Architectural Review Board Staff Report

Project Type: Amended Architectural Elevations

Description: **Gateway Studios, Lot 1A:** Amended Architectural Elevations for a 19.3-acre tract of land zoned "PC" Planned Commercial District located on the north side of Chesterfield Airport Road and east of Spirit of St. Louis Boulevard.

RE: Spirit of St. Louis Corporate Center (Gateway Studios) Lot 1
900 Spirit of St. Louis Blvd., Chesterfield, MO
ARB Comments - Main Building
GMA Job No. SJ2324

Figure 3: Revised West Side Elevation

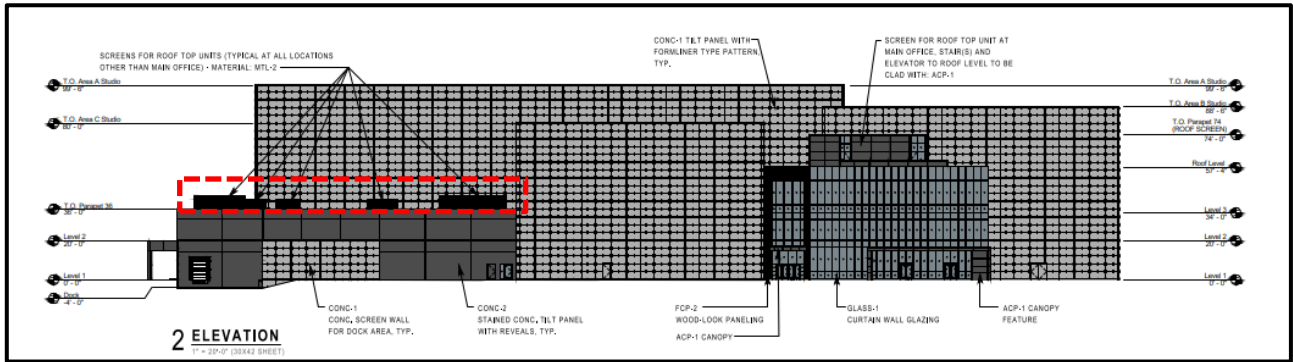
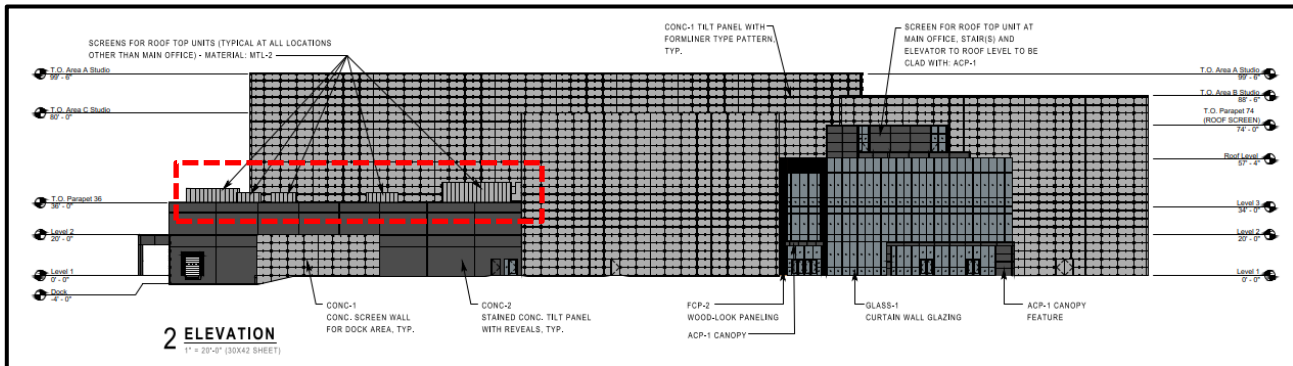
The applicant has submitted revised elevations addressing concerns raised by the ARB. During the November meeting there were three issues raised.

- First was related to the visibility to the proposed mechanical equipment. In the revised elevations, the applicant has revised the length, height and material of the roof top mechanical screening. The material selected is a flat, prefinished metal panel with joints aligned to correspond with the concrete wall panels.

Below are the revised and previously proposed elevations with roof top screening for the west side. All side revised elevations are attached in the packet.

Figure 4: Sight Line from Chesterfield Airport Road

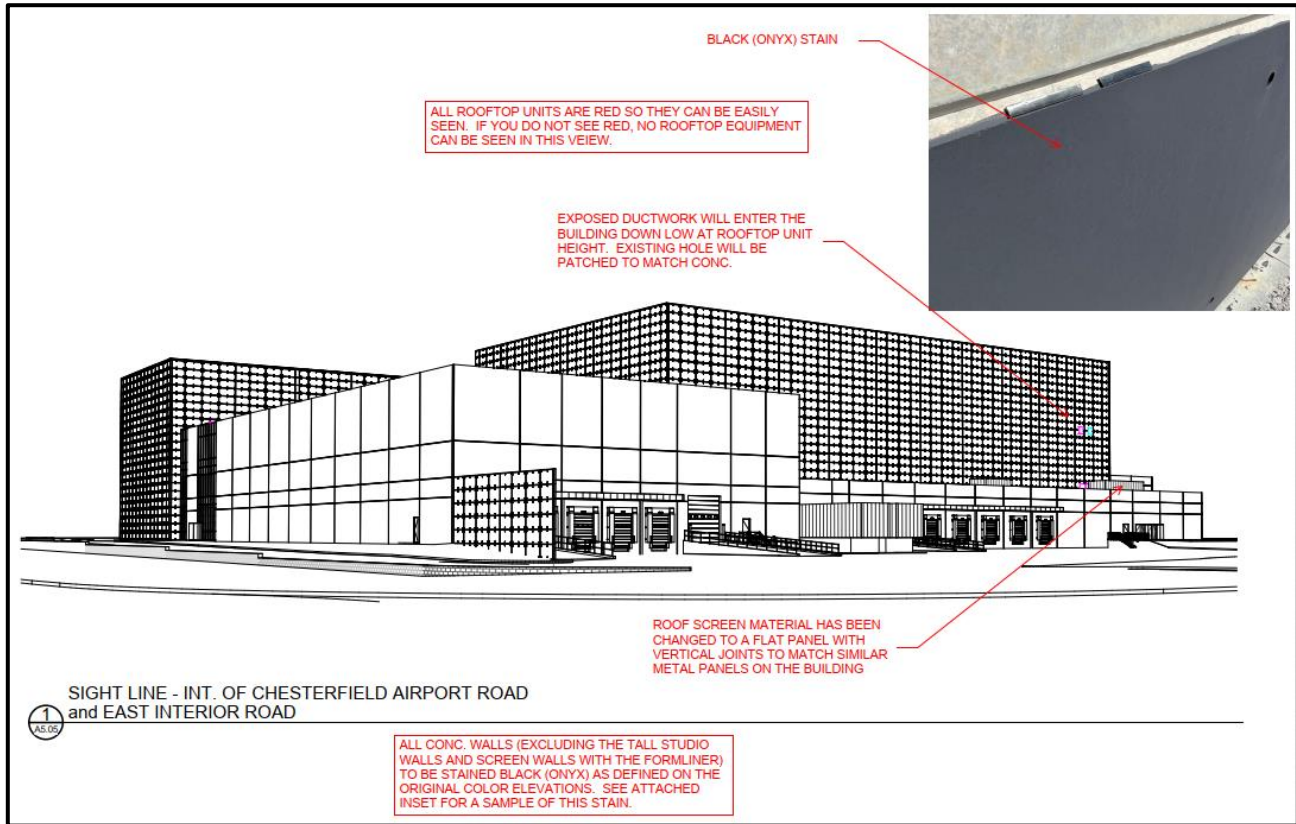
-We have reviewed the visibility of the equipment using Line of Sight models along both Chesterfield Airport Road and Spirit of St Louis Boulevard. In addition, we have also reviewed along the north and east property lines since, as discussed at the previous ARB meeting, this is considered a four-sided building.

We also discovered that, when looked at as a flat elevation, the screens were not depicted in a way appropriate to their actual location, which made them seem un-proportional to the building. We reviewed in the line-of-sight diagrams and the isometrics to see what was actually needing to be screened versus what was visible in a flat elevation. We have included those isometric and sight line views in this package to clarify locations and visibility.

Figure 3: Replaced Curtain wall on west

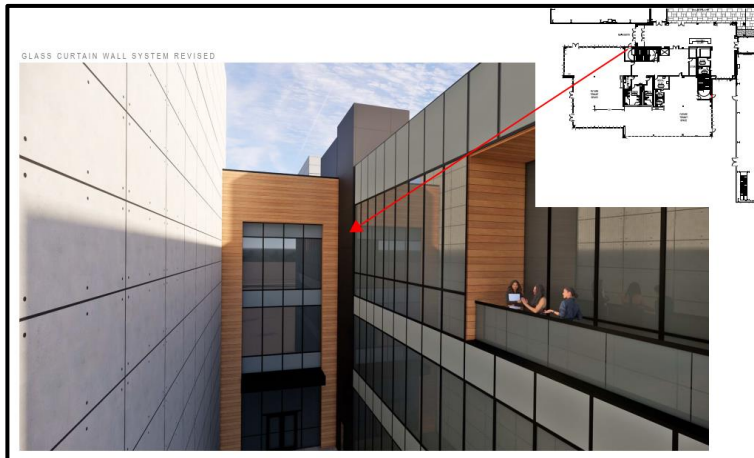
The Studio and the Office building of Gateway Studios is under construction. Applicant has submitted Amended Architectural Elevations to include the roof top mechanical equipment screening wall on the building. The tallest screening will be 17’ high that will be visible from west and north side of the building. Additionally, the proposed curtain walls on the west and south interior walls will be replaced by ACM paneling which is similar to the roof deck area as shown in figure 3 and 4.

ITEM 4: The Board complimented the elegance of the internal curtain wall with ACM paneling on the main building.

- Thank you for this approval. We will proceed with this adjustment to the main building.

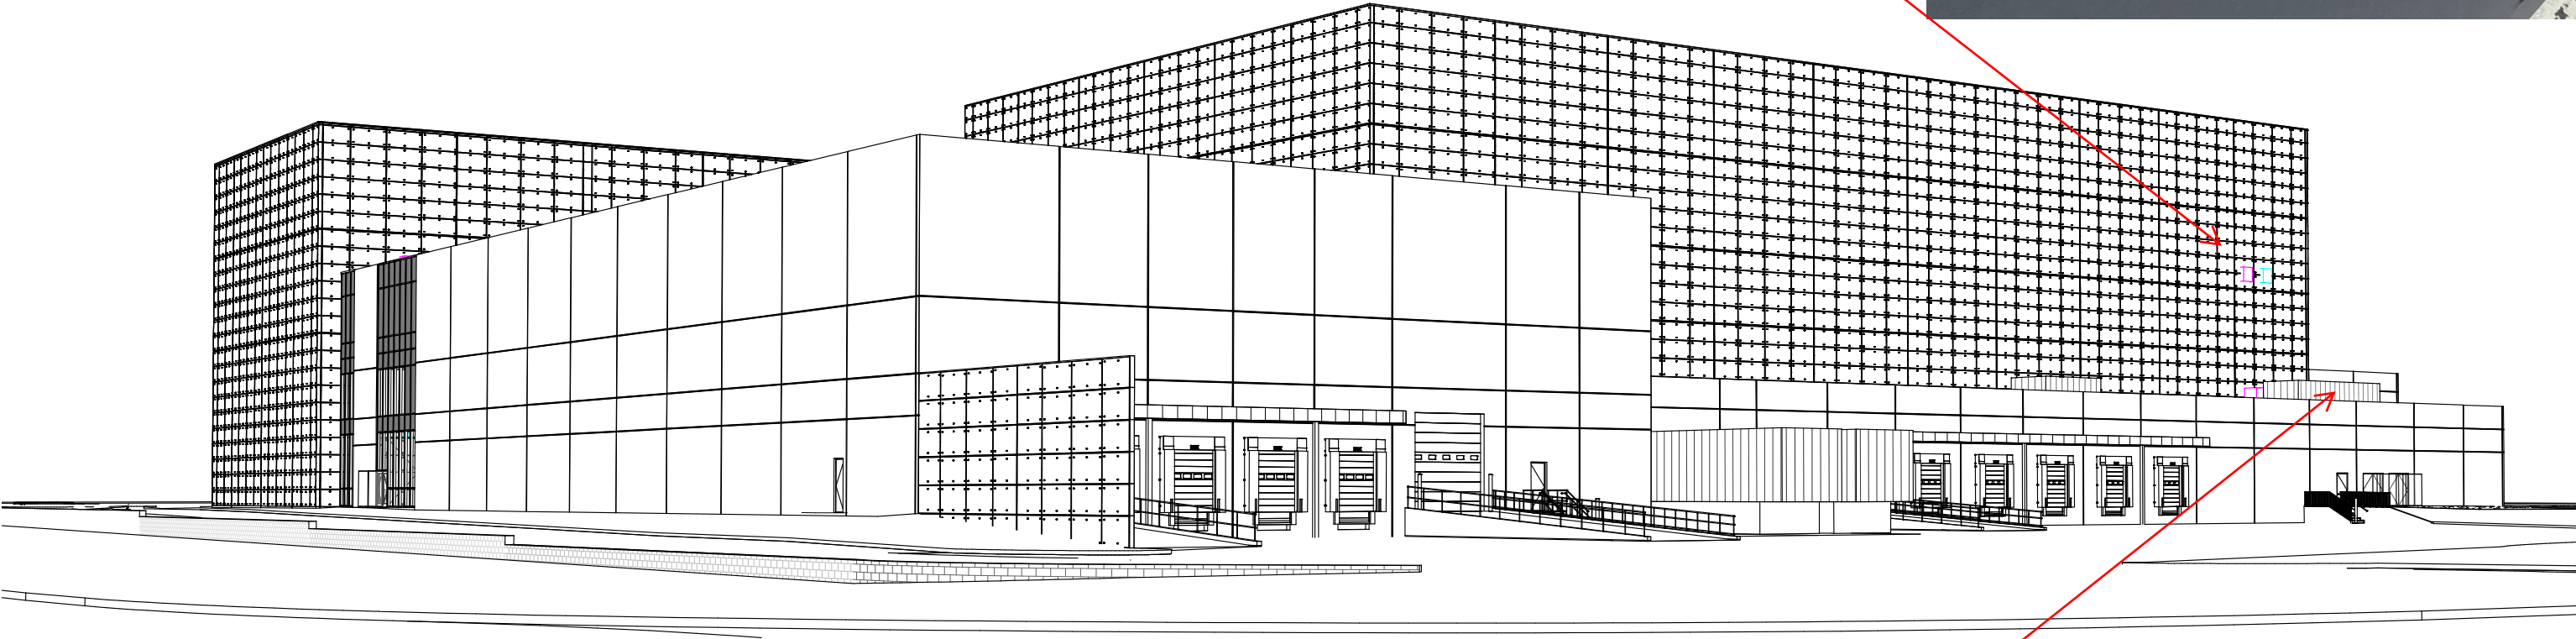
EXPOSED DUCTWORK WILL ENTER THE BUILDING DOWN LOW AT ROOFTOP UNIT HEIGHT. EXISTING HOLE WILL BE PATCHED TO MATCH CONC.

ROOF SCREEN MATERIAL HAS BEEN CHANGED TO A FLAT PANEL WITH VERTICAL JOINTS TO MATCH SIMILAR METAL PANELS ON THE BUILDING

SIGHT LINE - INT. OF CHESTERFIELD AIRPORT ROAD and EAST INTERIOR ROAD

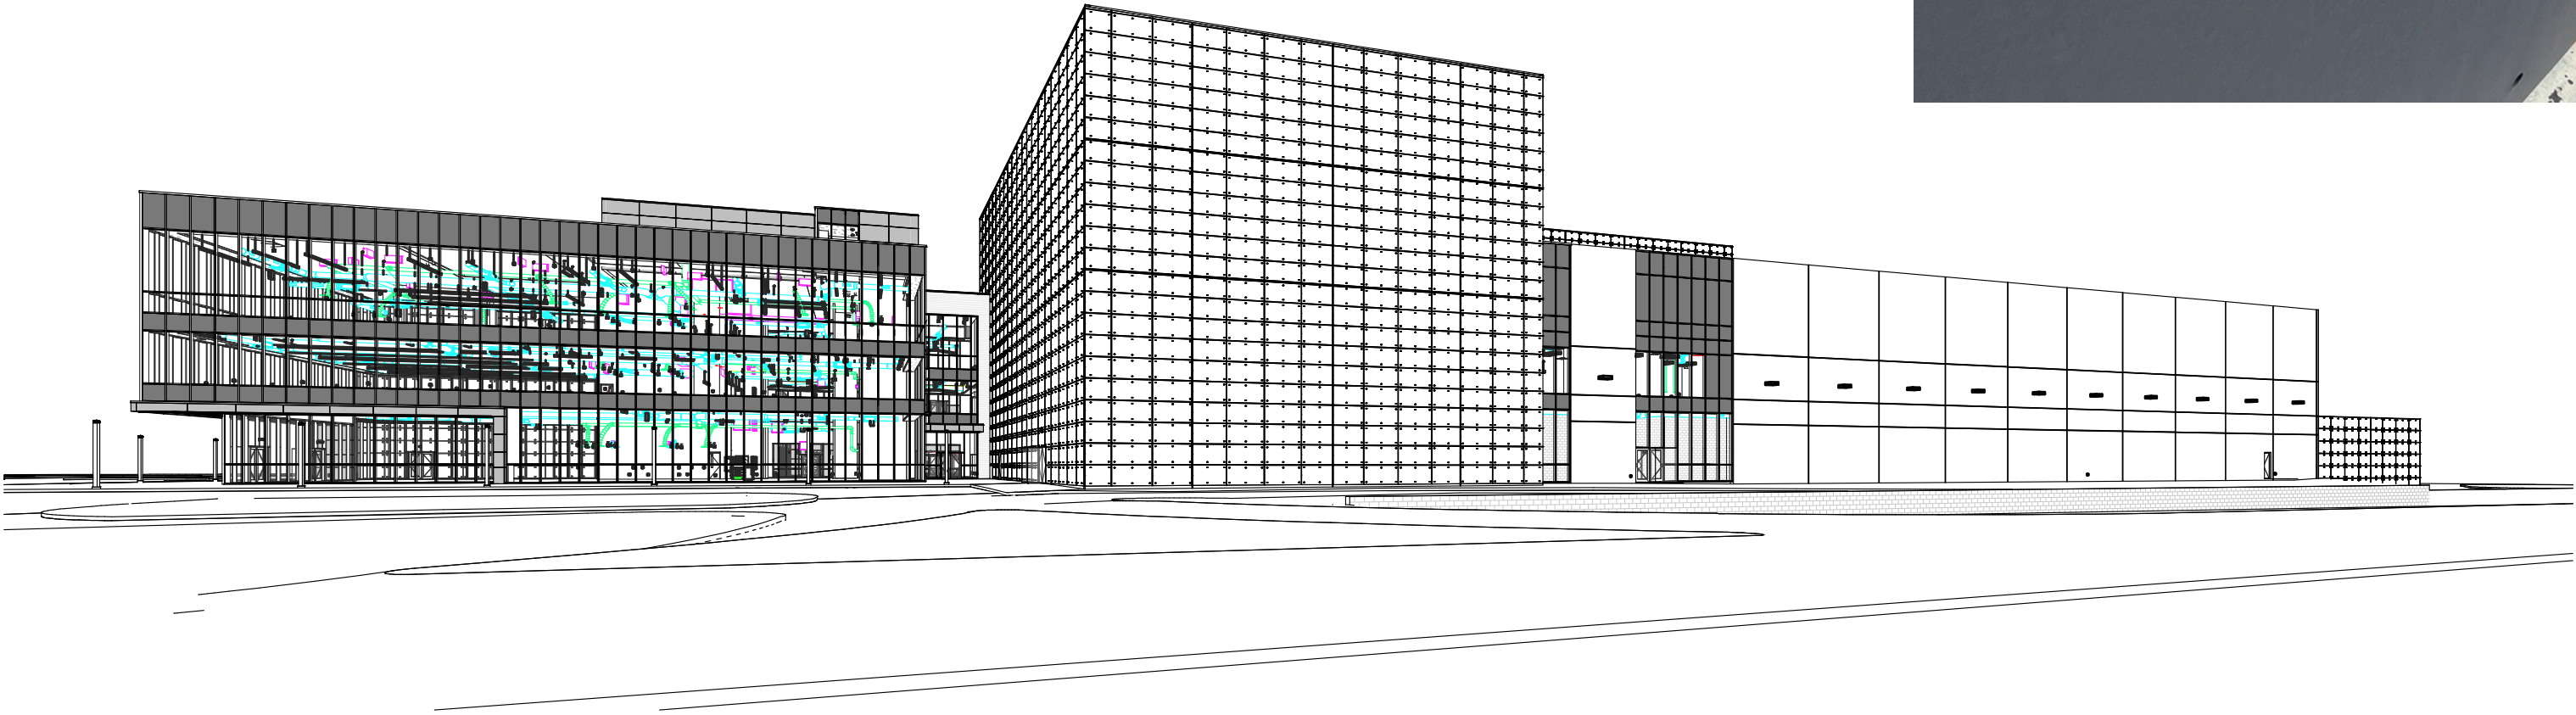
ALL CONC. WALLS (EXCLUDING THE TALL STUDIO WALLS AND SCREEN WALLS WITH THE FORMLINER) TO BE STAINED BLACK (ONYX) AS DEFINED ON THE ORIGINAL COLOR ELEVATIONS. SEE ATTACHED INSET FOR A SAMPLE OF THIS STAIN.

SIGHT LINE - INT. OF SPIRIT and CHESTERFIELD AIRPORT ROADS

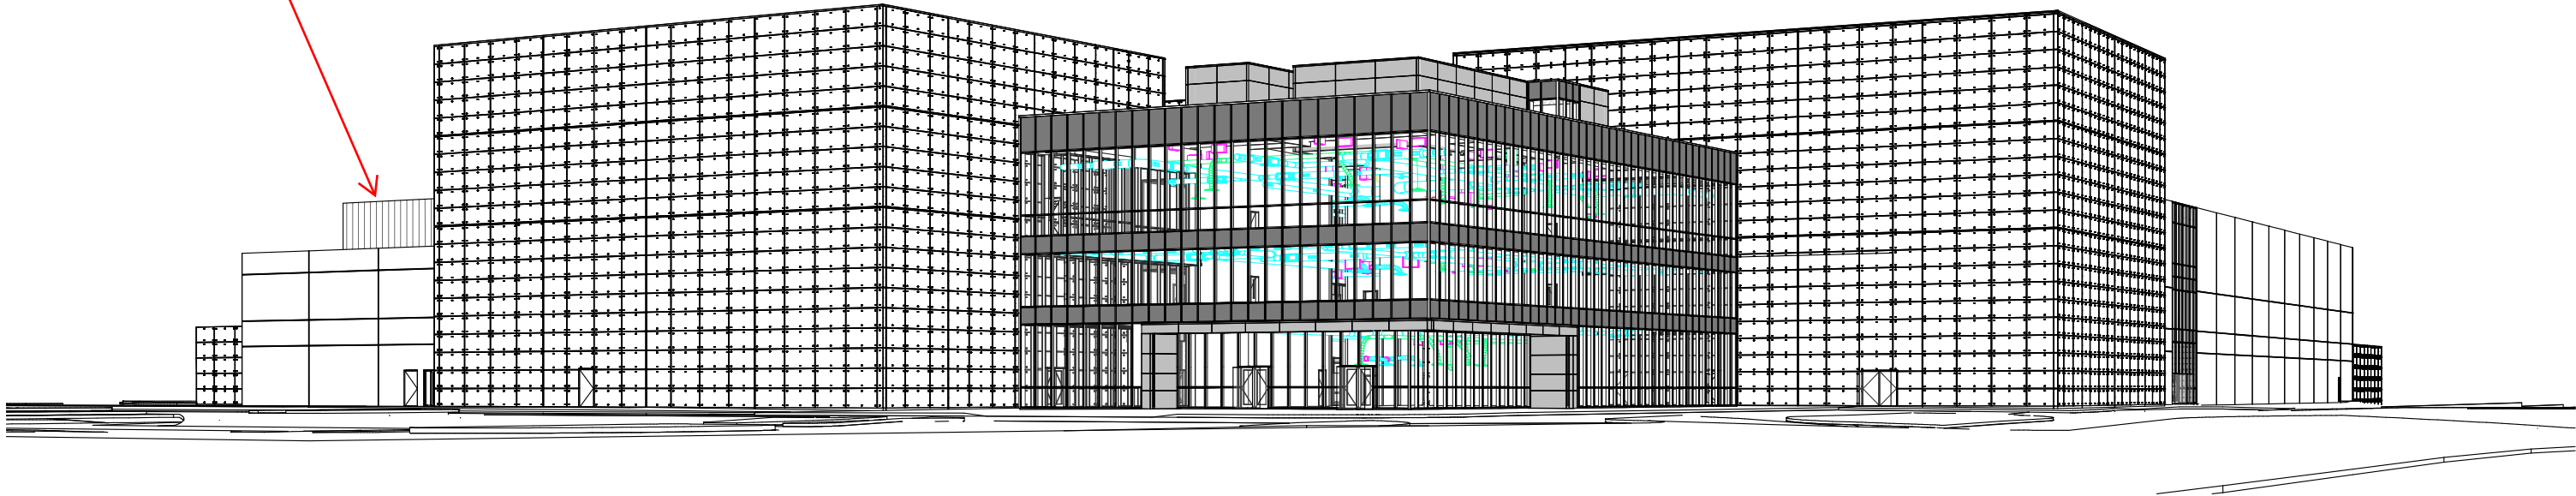
ALL CONC. WALLS (EXCLUDING THE TALL STUDIO WALLS AND SCREEN WALLS WITH THE FORMLINER) TO BE STAINED BLACK (ONYX) AS DEFINED ON THE ORIGINAL COLOR ELEVATIONS. SEE ATTACHED INSET FOR A SAMPLE OF THIS STAIN.

ROOF SCREEN MATERIAL HAS BEEN CHANGED TO A FLAT PANEL WITH VERTICAL JOINTS TO MATCH SIMILAR METAL PANELS ON THE BUILDING

SIGHT LINE - INT. OF SPIRIT and NORTH INTERIOR ROAD

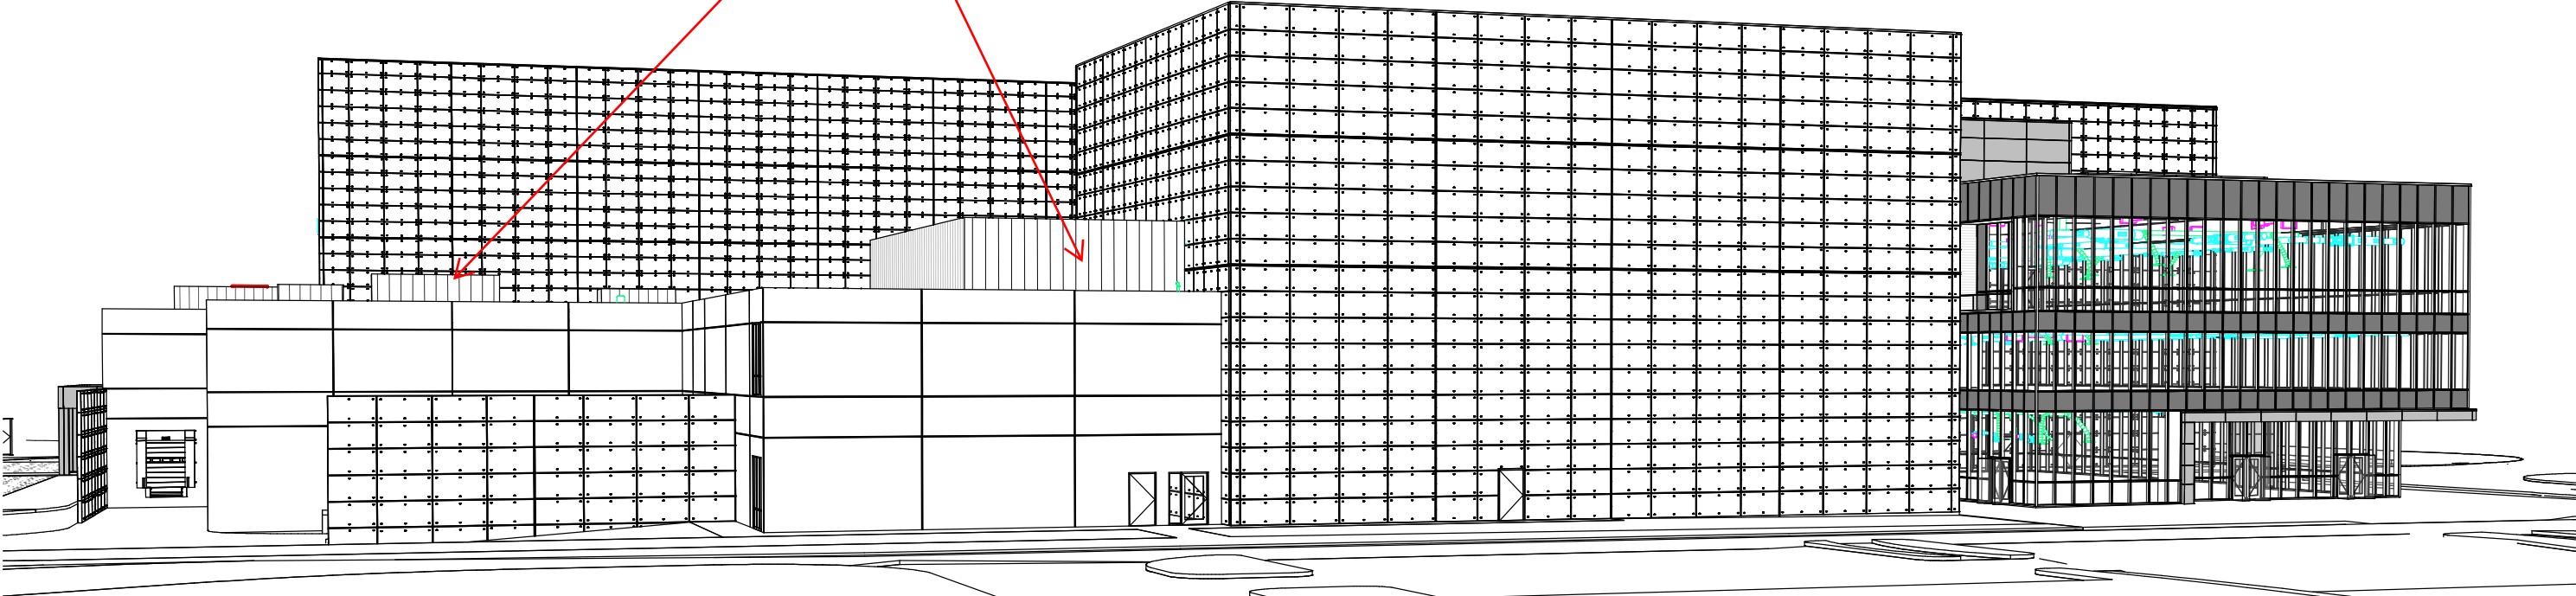
ROOF SCREEN MATERIAL HAS BEEN CHANGED TO A FLAT PANEL WITH VERTICAL JOINTS TO MATCH SIMILAR METAL PANELS ON THE BUILDING

ALL CONC. WALLS (EXCLUDING THE TALL STUDIO WALLS AND SCREEN WALLS WITH THE FORMLINER) TO BE STAINED BLACK (ONYX) AS DEFINED ON THE ORIGINAL COLOR ELEVATIONS. SEE ATTACHED INSET FOR A SAMPLE OF THIS STAIN.
